Project	IEEE 802.16 Broadband Wireless Access Working Group < http://ieee802.org/16 >	
Title	PDU sequencing in IEEE 802.16e Sleep Mode	
Date Submitted	2003-07-18	
Source(s)	Changhoi Koo Jungje Son Yeongmoon Son Sohyun Kim Samsung Elec. 416, Maetan-3dong, Paldal-gu Suwon-si, Gyeonggi-do, Korea	Voice: +82-31-279-5091 Fax: +82-31-279-5130 chkoo@samsung.com binde.kim@samsung.com ym1004.son@samsung.com jungje.son@samsung.com
Re:	IEEE 802.16e Sleep mode operation	
Abstract	This document is to propose the response message corresponding to MOB_TRF-IND message and PDU sequence numbering on the new proposed message and existing MOB_TRF-IND message both in order to provide concrete sleeping mode operation and more power saving as well as synchronization between BS and MSS while in transmitting packet data. This document has been introduced as a one of proposals in the last meeting (IEEE802.16e-03-31).	
Purpose	Present how the IEEE802.16a can be enhanced in order to support mobility.

PDU sequencing in IEEE802.16e Sleep Mode

Figure 2. Corrupted transmission and sleeping mode transition

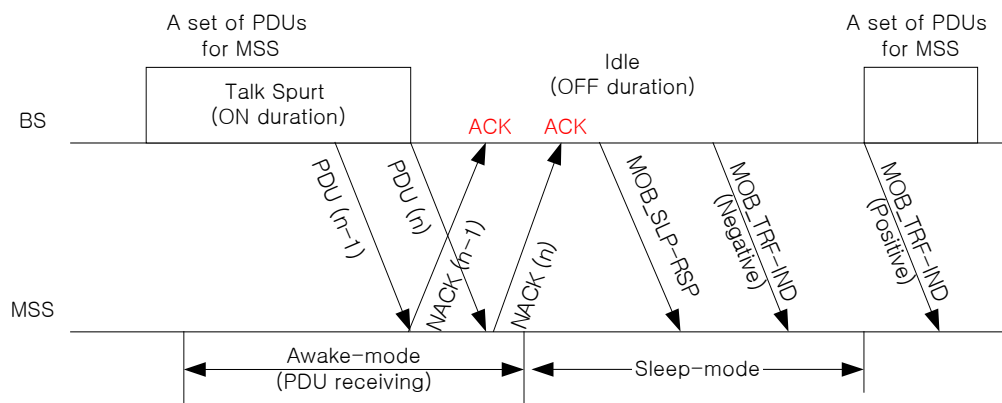
In figure 2, because the BS has been received ACKs by corruption even the MSS transmitted NACK for n and n-1 PDU, respectively, the BS will complete the transmission for this packet data burst and transmit MOB_SLP_RSP message to indicate mode change, awake mode to sleep mode. Accordingly, the MSS shall be transited into the sleep mode without supplementary packet receiving corresponding to NACKed PDUs (n and n-1). In this case, the ARQ_TX_window_START will be set to "n+1" at the BS side and ARQ_RX_window_START will be set to "n-1". After sleeping mode, the BS will resume PDU transmission with next PDU sequence number, PDU (n+1), at the next packet data burst transmission even the MSS effectively or successfully received up to PDU (n-2). To avoid this kind of asynchronous transmission, PDU sequence number for ARQ_TX and ARQ_RX

window start value should be indicated and exchanged between the BS and MSS through both MOB_TRF_IND message and MOB_TRF_CFN message proposed, respectively.

Therefore, we propose the new information element, 8bits on the MOB_TRF-IND message and MOB_TRF-CFN proposed message, in order to guarantee the reliable PDU transfer under the synchronized ARQ_TX_window_START and ARQ_RX_window_START. These additional procedures are to maintain the transmission synchronization as well as to save the power consumption from undesirable retransmission or aperture transmission.

Figure 3. Uncompleted transmission and sleeping mode transition

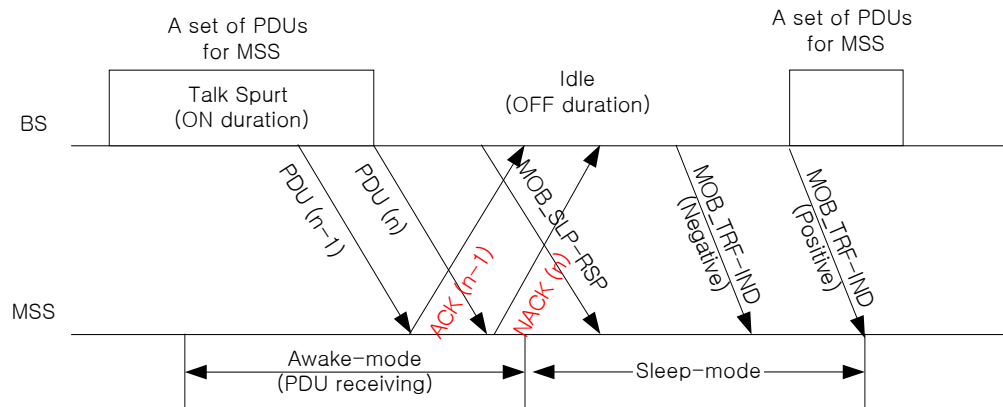
Figure 3 shows the mode changes during uncompleted transmission. If the BS transmits the MOB_SLP_RSP message to the MSS without receiving response message to the PDUs generated from the end portion of the burst, the PDU sequence number transmitted and received can be different between the BS and MSS. For more power saving, the BS can do this operation to accelerate fast sleep mode transition, and PDUs (n) reported and received as NACKed after transmitting MOB_SLP_RSP message will be transmitted at the beginning of the next packet data burst transmission. To avoid this kind of asynchronous transmission, PDU sequence number for ARQ_TX and ARQ_RX window start value should be indicated and exchanged between the BS and MSS through both MOB_TRF_IND message and MOB_TRF_CFN message proposed.
